**RE: SUBMISSION TO SSD - 79276958, Residential development with infill affordable housing  
Address: 59-63 TRAFALGAR AVENUE AND 1A&1B VALLEY ROAD, LINDFIELD**

**However, I object in the strongest terms to the proposed development SSD – 79276958. The proposed development's height, bulk and scale are completely unsuitable for the area. Critically the applicant's submission does not comply with SEARs and other planning and legislative requirements.**

The following pedestrian access distance diagram is included in the applicant's Design Report – Appendix D – page 14

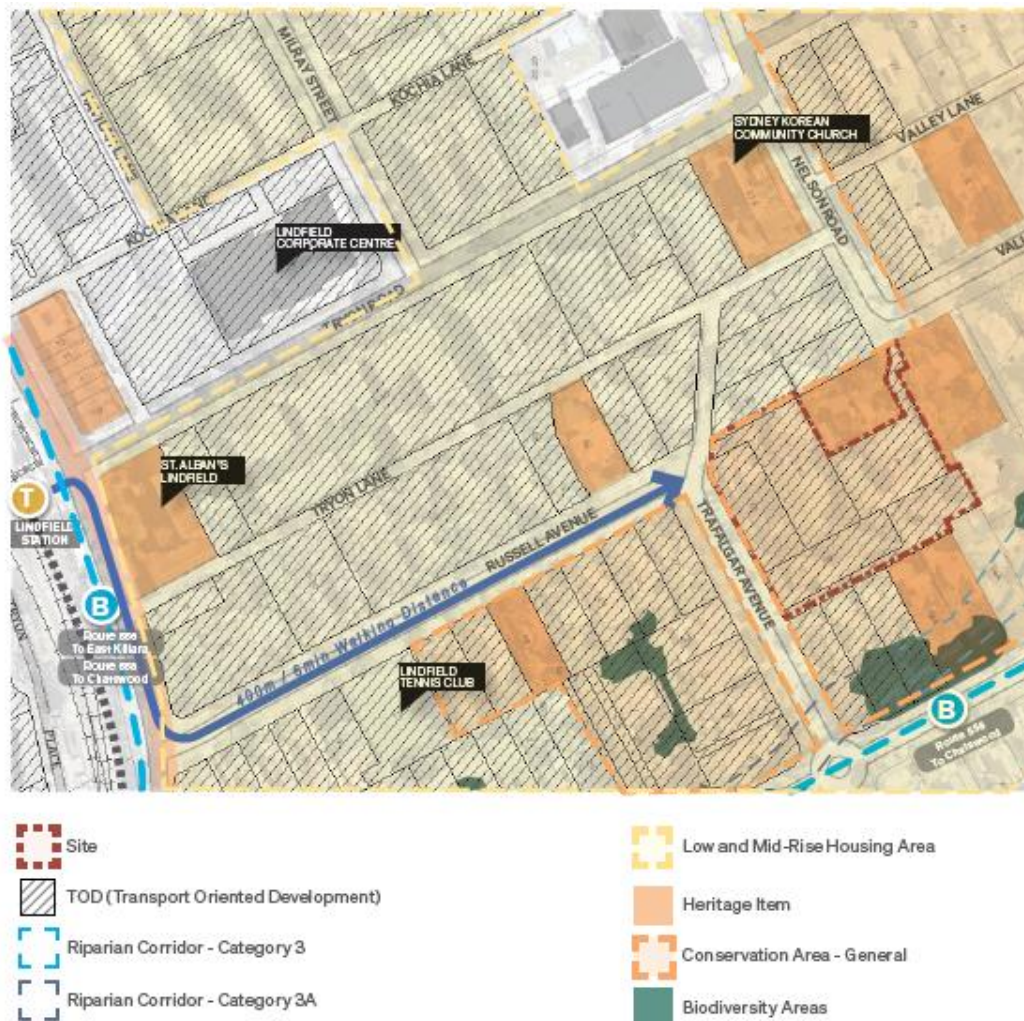
We have engaged a surveyor to carry out a survey to determine the walking distance along the same route the applicant has presented in their submission from the closest point at 61 Trafalgar Avenue to Lindfield Station – please refer to Appendix 1.

***The survey concludes that the total walking distance from 61 Trafalgar Avenue to Lindfield Station is 433.7 metres. This exceeds the 400-metre TOD requirement for developments of this type. The total walking distance from the main entry of the proposed development is 464.2 metres.***

The applicant's proposal in terms of a safe walking route to the station overlooks the need to use the pedestrian crossing at the busy intersection of Tryon and Lindfield Avenue as well as the traffic lights to cross at Lindfield Avenue. These have been considered in the survey carried out and referred to in Appendix 1.

**The proposed development is outside the 400-metre walking distance from Lindfield Station, contrary to the applicant's assertion. Consequently, the TOD mapping is inaccurate and must be revised to exclude the proposed development area.**

## Preferred Scenario - Lindfield

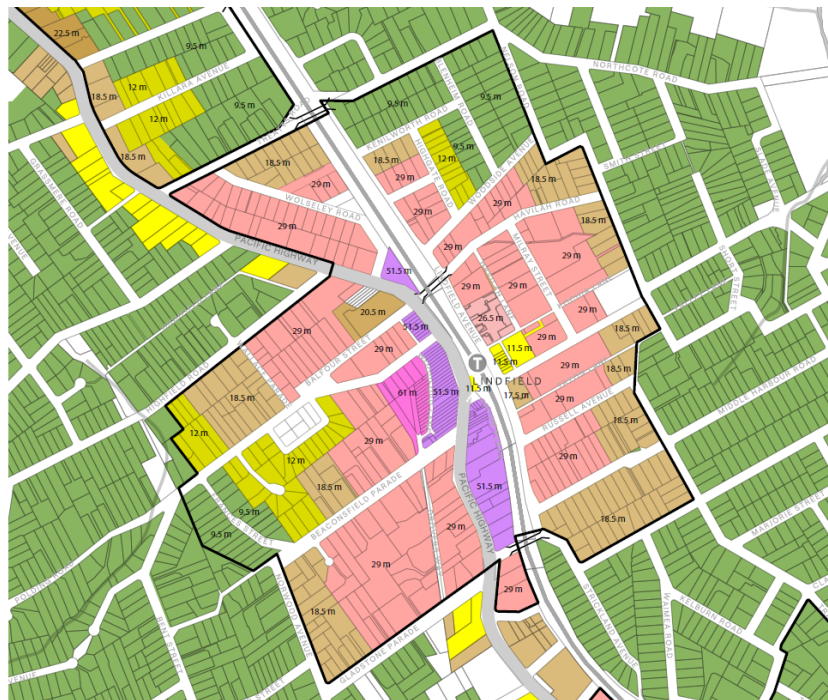
The TOD preferred alternative scenario developed by Ku-ring-gai Council and in extensive consultation with the local community excludes the proposed development site and adjoining properties from within the TOD boundary. As the Department is aware, this scenario is designed to meet the New South Wales State Government housing targets while also delivering on 7 principles important to the community, which include - avoid environmentally sensitive areas, minimise impact on

The EIS should address the draft KLEP and has not. Under the TOD Preferred Alternative Scenario, the proposed development site and adjoining properties are zoned R2. Consequently, the proposed development will be prohibited under the planning controls of the TOD Preferred Alternative Scenario.

Please refer to the below per Ku-ring-gai Council's exhibition document and exclusion of the proposed development area.
